# The Good, The Bad, The Ugly!

Midwest Geotech Conference 2025

# Route F over the Sac River Branch Bridge Replacement Southwest Missouri

PROJECT NO. B250-4632	ROCK CORE PHOTOGRAPHS A9615 Bent 3 Shaft 3 (12.5' to 39')	Figure
DRAWN BY: JMH		A-1
CHECKED BY: MWL	Route NN over Platte River Nodaway County, Missouri

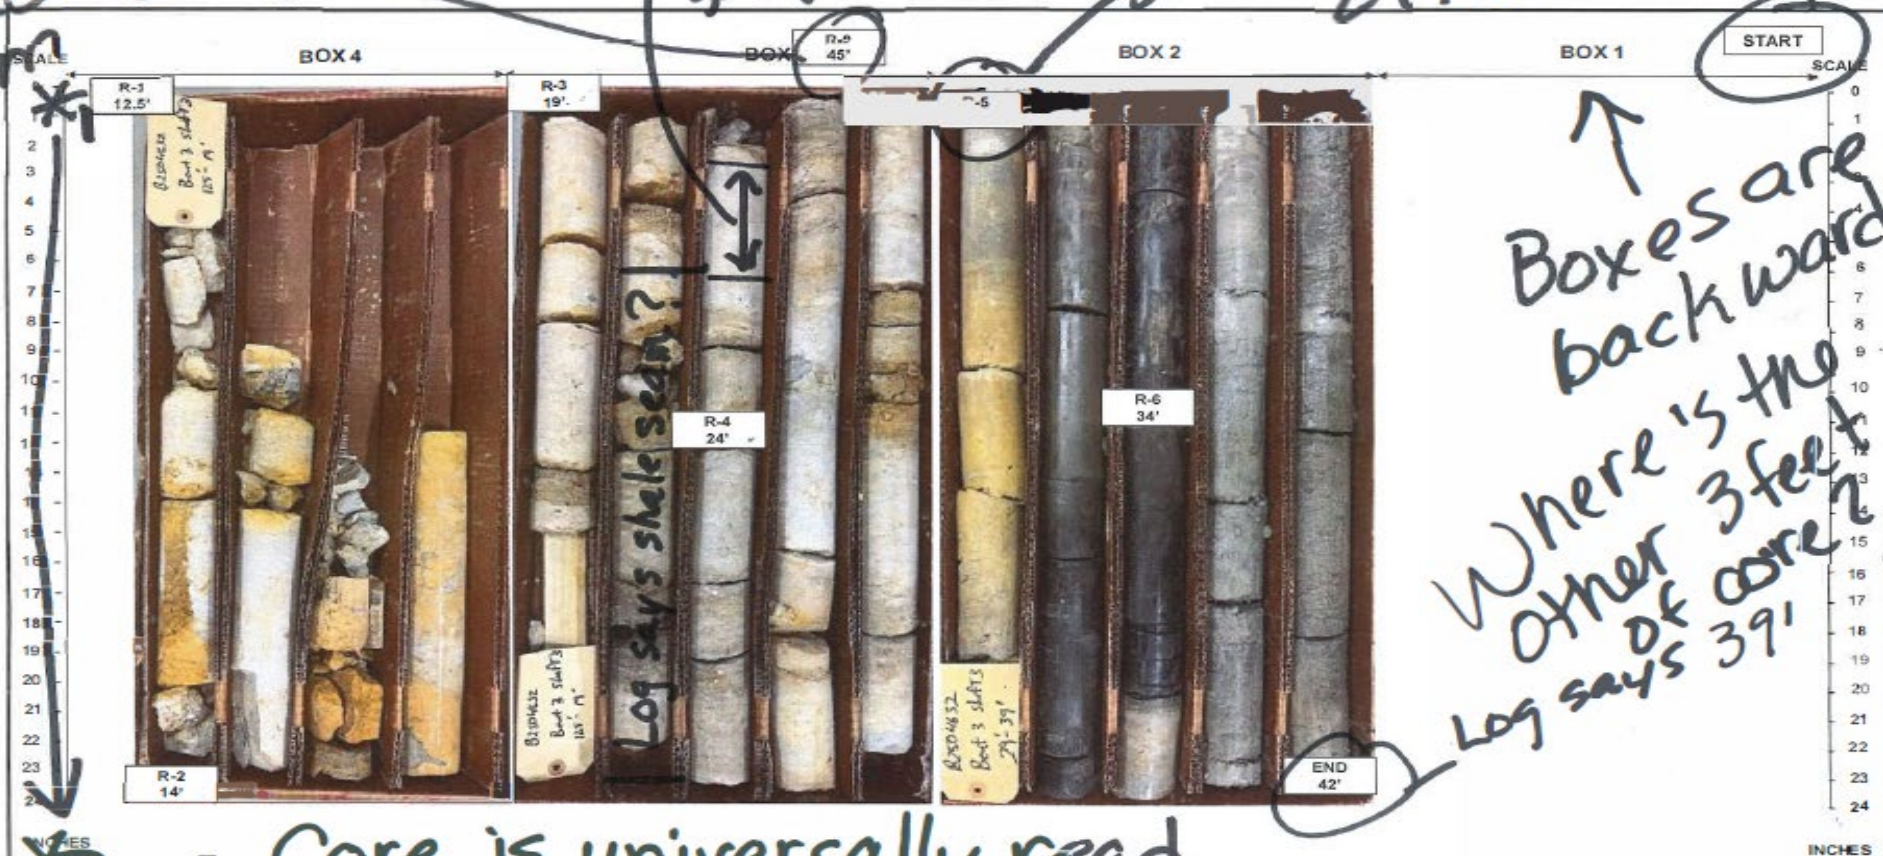
Are we reading from ~~\*~~

Log skys washout?

Should this be 29 feet?

↑  
Boxes are  
backwards.  
Where is the  
other 3 feet  
of core?  
Log says 39'

Core is universally read  
from left to right  
in a box laying horizontally
